FIRE ALARM SYSTEM SHOP DRAWINGS FOR:

City of Aurora Plan Review
Project COLORADO ENT. FIRE ALM
Address 1400 S. POTOMAC #240
Contractor FIRE ALARM
RSN SERVICES INC. 5422(2)
Permit Number ID-476798
Plan Location STRUCTURE

AURORA BUILDING DEPARTMENT
LIFE SAFETY SYSTEMS
APPROVED
SUBJECT TO CORRECTIONS AS INDICATED AND FIELD INSPECTIONS WITH FUNCTIONAL TESTS
APPROVED JUN 17 2010
SIGNED DATE

FIRE ALARM SYSTEM TENANT FINISH FOR: COLORADO ENT SPECIALISTS REMODEL/EXPANSION

DRAWING TITLE: SUITE 240 FIRE ALARM PLAN

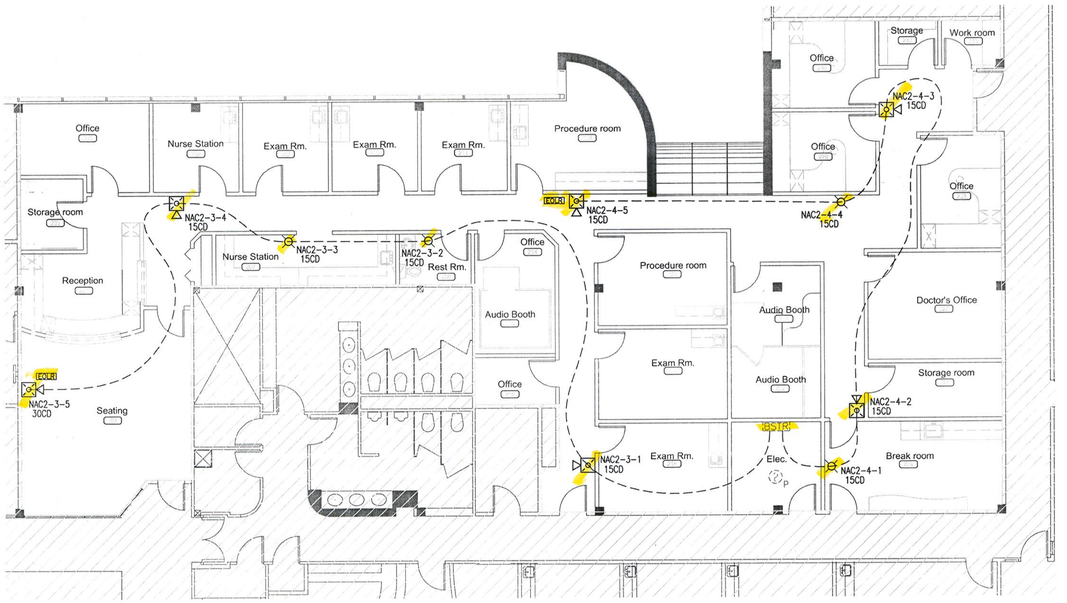
ADDITIONAL GENERAL NOTES — ADD TO FUTURE SUBMITTALS

- THE FIRE ALARM INSTALLATION CONTRACTOR MUST COMPLETE THE NFPA 72 "RECORD OF COMPLETION" PRIOR TO SCHEDULING THE AHJ ACCEPTANCE TEST.
- FIELD INSPECTION CONSULTATION IS AVAILABLE UPON REQUEST. CALL 303-739-7420 TO REQUEST CONSULTATION.
- AUDIBLE ALARM SIGNALING DEVICES SHALL EXCEED THE PREVAILING SOUND LEVEL IN A ROOM OR SPACE BY 15 DBA. SOUND LEVELS FOR ALARM SIGNALS SHALL BE 120 DBA MAXIMUM. IFC SECTION 907.10.2.
